FINAL DEVELOPMENT PLAN APPLICATION

## Project Name/Business Name: ______All R Friends

## Final Development Plan

Development Plan Review Response 2017052601 Revision

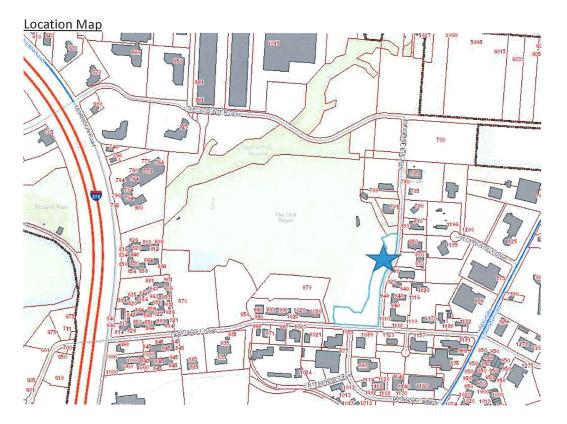
- a) 40%-70% of the main façade for office uses shall be window openings. An updated rendering has been provided. It appears that the main façade (east elevation) meets the aforementioned requirement.
- b) All buildings shall provide a minimum tree planting within the interior of the site to help provide shade and increase aesthetic value. Trees shall be a minimum of 2" in caliper.
   An updated site plan has been provided. The tree size, 2 ½", meets the requirements of the overlay.
